VIRGINIA ELECTRIC AND POWER COMPANY
RICHMOND, VIRGINIA 23261

VIRGINIA ELECTRIC AND POWER COMPANY
NORTH ANNA POWER STATION UNITS 1 AND 2
PROPOSED TECHNICAL SPECIFICATIONS CHANGES
EDITORIAL CORRECTION TO PROPOSED REACTOR COOLANT SYSTEM
PRESSURE/TEMPERATURE LIMIT CURVES APPLICABLE TO COOLDOWN

Attachment: Corrected North Anna Units 1 and 2 Technical Specifications Figures
3.4-3, Reactor Coolant System Cooldown Limitations

**Corrected North Anna Units 1 and 2
Technical Specifications Figure 3.4-3
Reactor Coolant System Cooldown Limitations**

North Anna Unit 1
Reactor Coolant System Cooldown Limitations

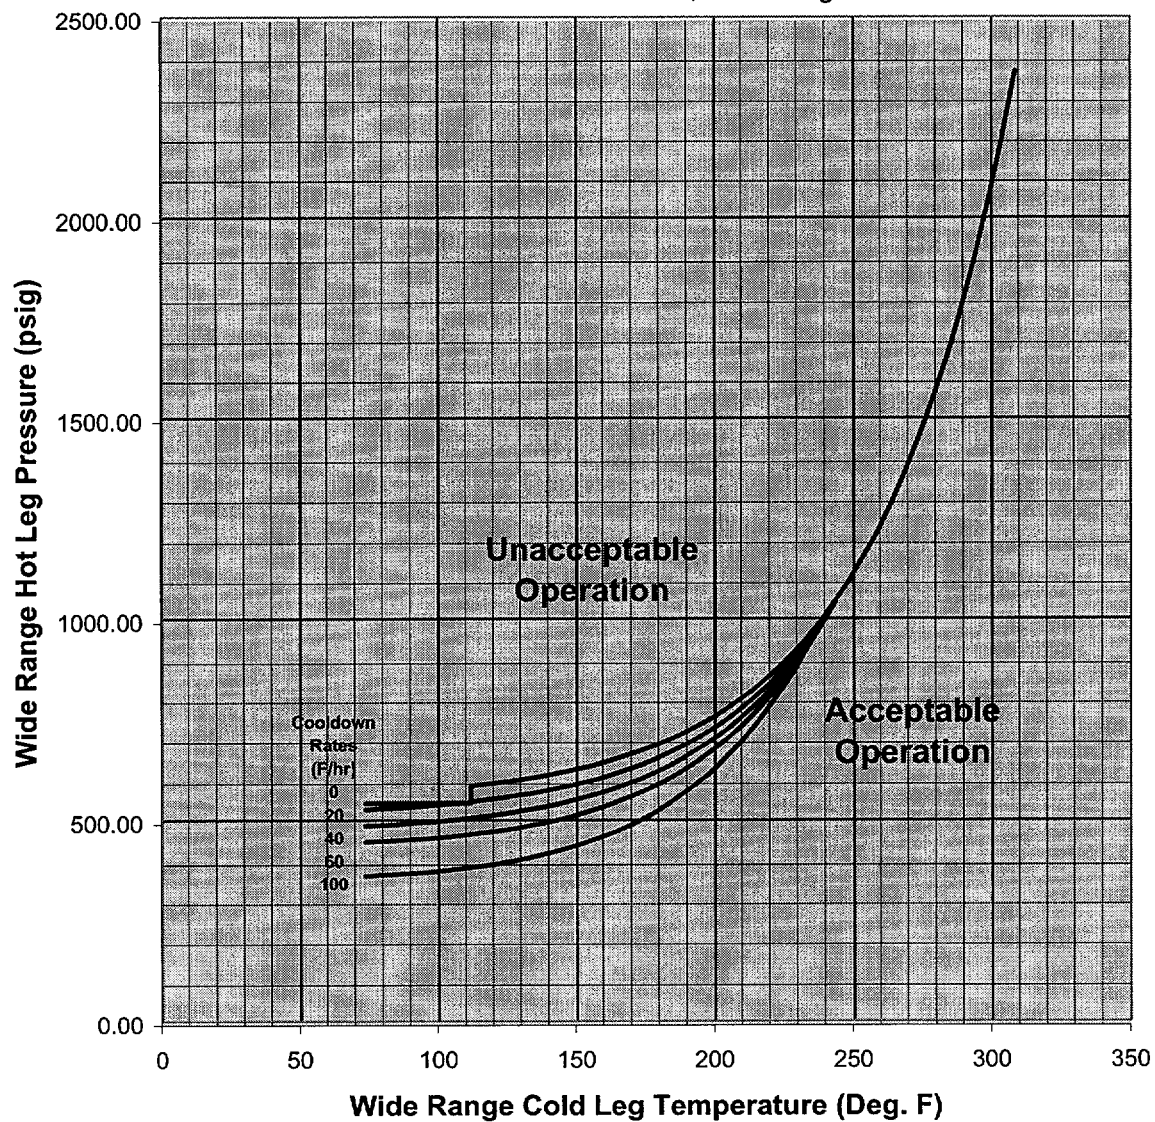
By letters dated June 22, 2000, January 4, 2001, and March 22, 2001, Virginia Electric and Power Company (Dominion) submitted a Technical Specification Change Request (TSCR) involving the Reactor Coolant System (RCS) Pressure/Temperature (P/T) operating limits, the Low Temperature Overpressure Protection System (LTOPS) setpoints, and the LTOPS enable temperature. North Anna Units 1 and 2 Technical Specification Figures 3.4-3 present RCS P/T limits applicable to cooldown (i.e., "cooldown curves"). These figures include inset text boxes that describe the cooldown rate for which each cooldown curve is applicable. During preparation for implementation of the proposed Technical Specifications, it was noted that the inset text boxes on the proposed North Anna Units 1 and 2 cooldown curves submitted by letter dated January 4, 2001 were mislabeled. Specifically, the inset text box is labeled "Heatup Rates" instead of "Cooldown Rates."

The attachment to this letter provides cooldown curves with inset text box labels that have been corrected to read "Cooldown Rates." Except for this editorial change, the attached cooldown curves are unchanged from those previously submitted. Please replace the proposed North Anna Units 1 and 2 Technical Specification Figures 3.4-3 previously submitted by letter dated January 4, 2001 with those provided in the attachment to this letter.

North Anna Unit 1 Reactor Coolant System Cooldown Limitations (Cooldown Rates up to 100 F/hr)
Applicable for the first 32.3 EFPY (Including Margins for Instrumentation Errors)
